ADDENDUM NO. 2

Date: March 21, 2024

Project: West Regional Library Renovation
Cary, NC

M503

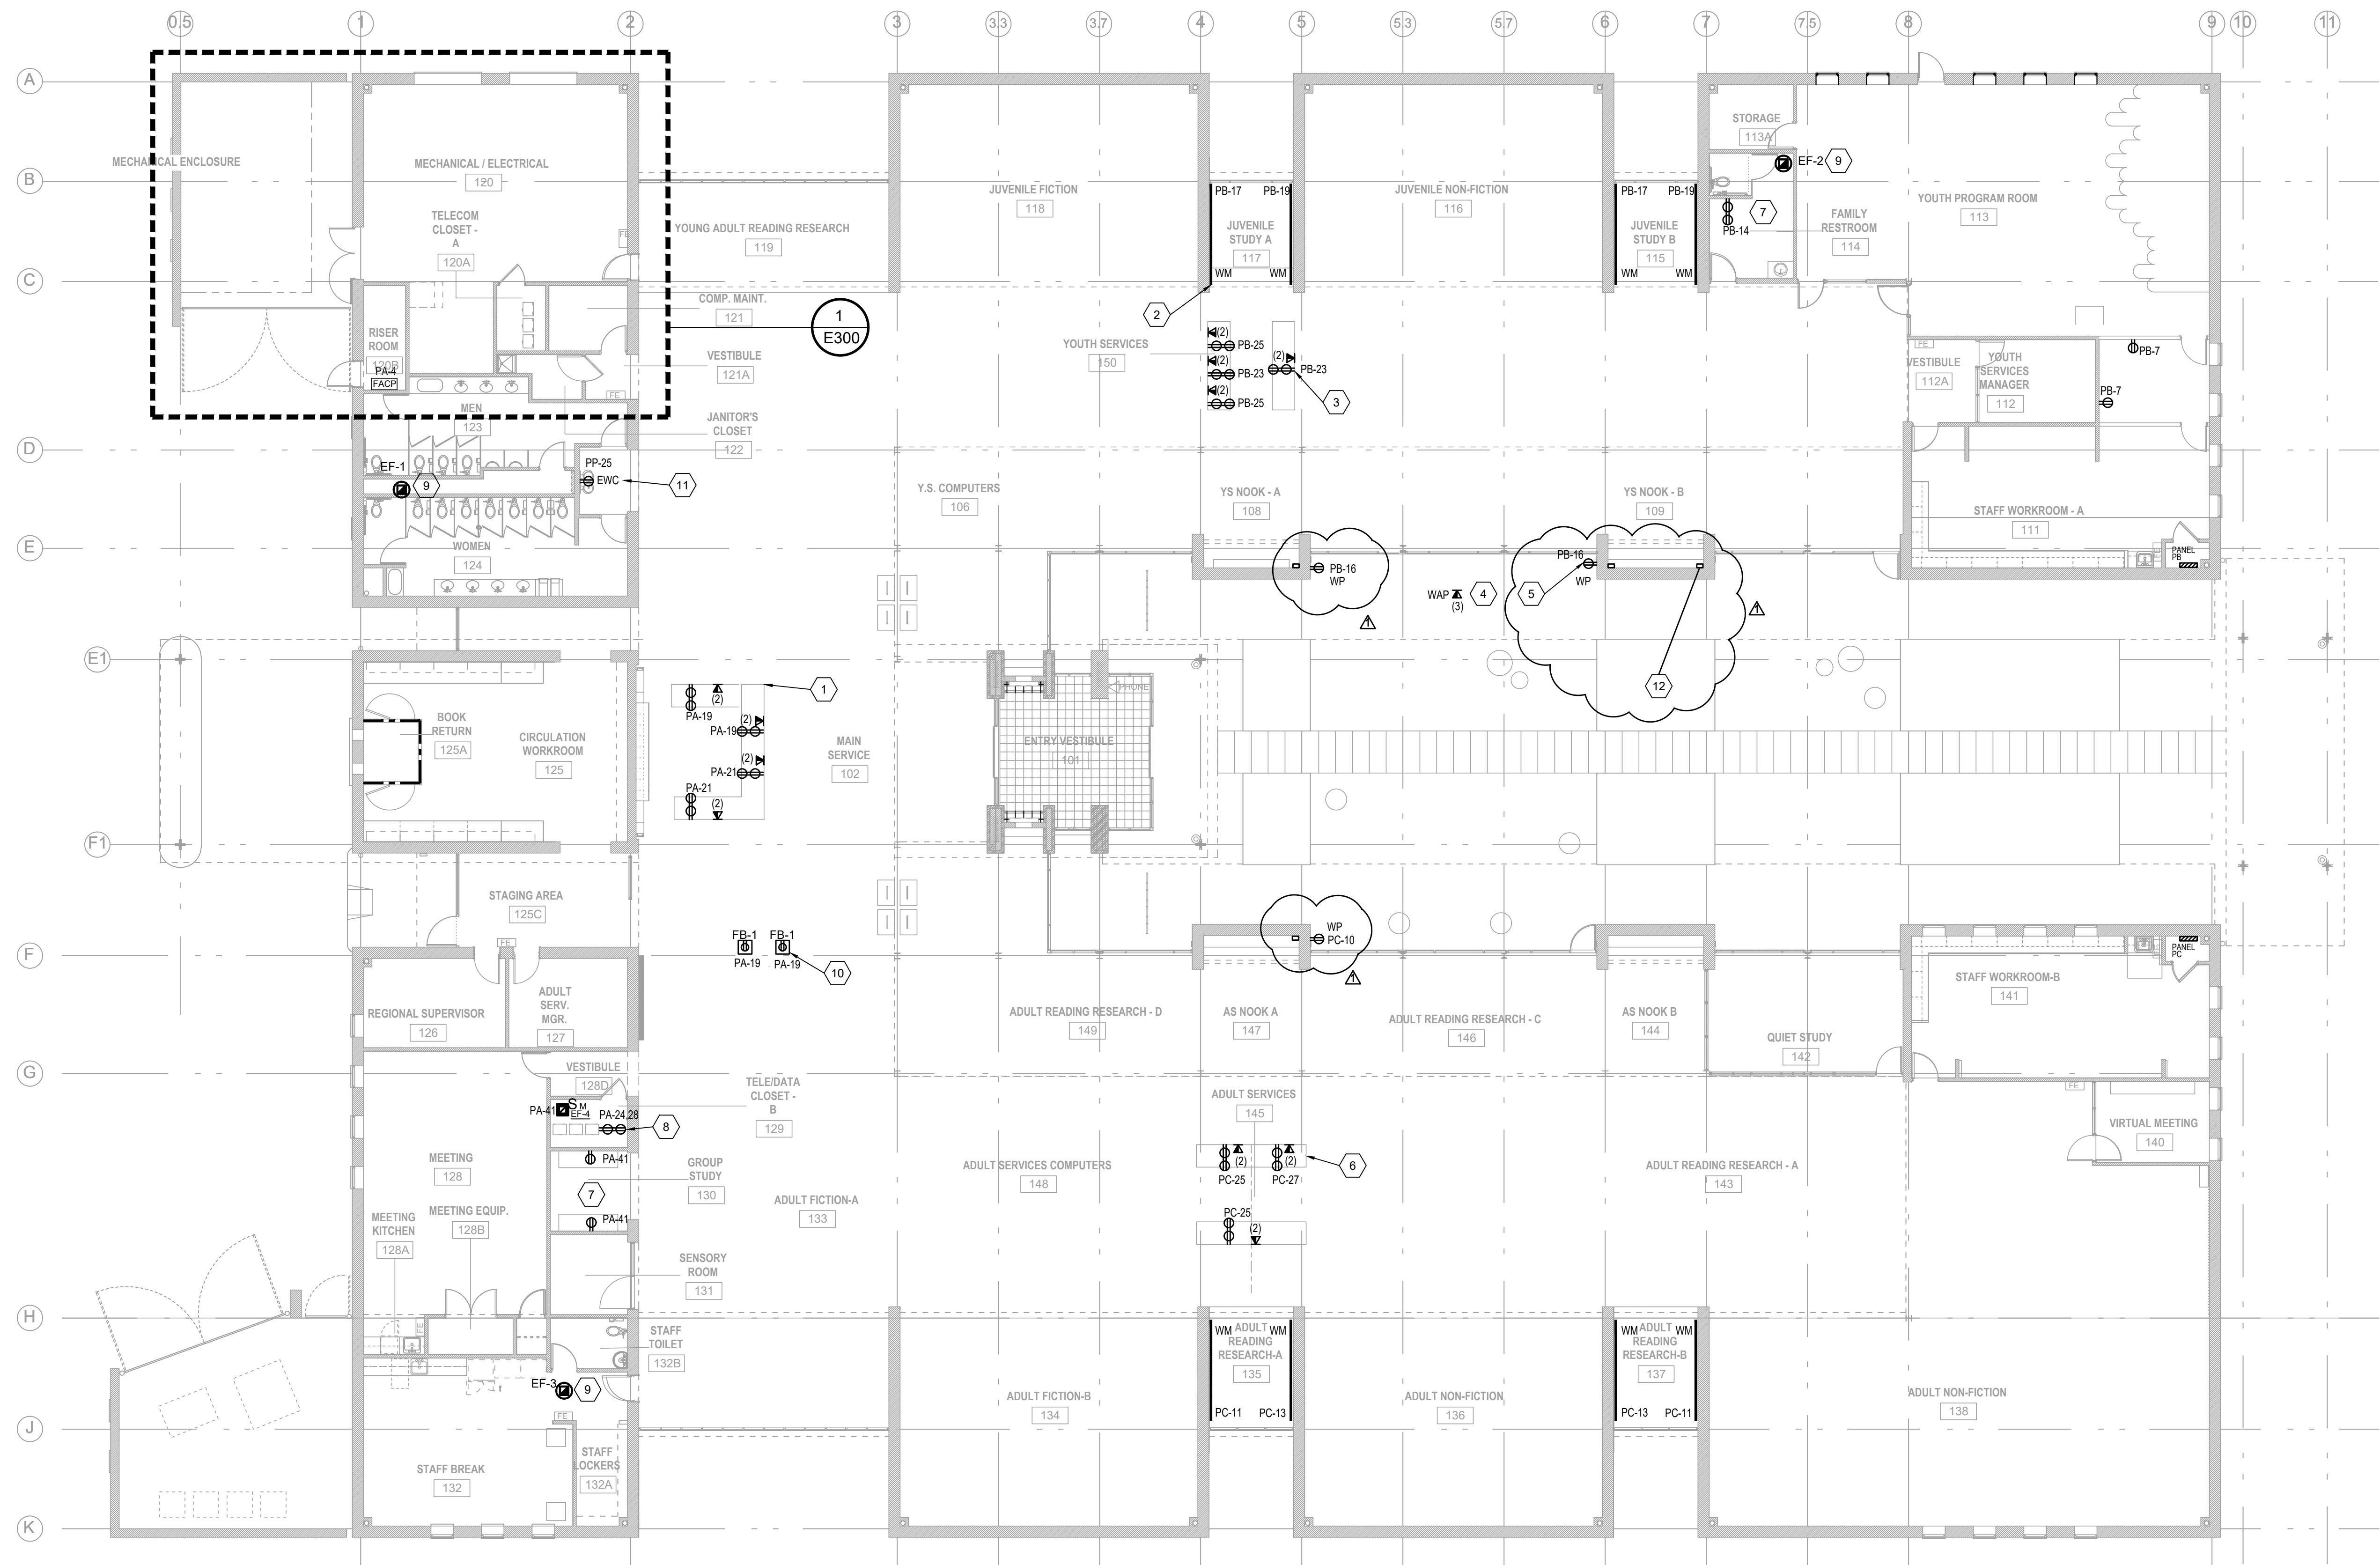
ITEM 18: New Sheet M503-sheet has been **added** to denote division of work detail as well as outline responsibilities between Div 23 and 26 as it relates to disconnects and final connections.
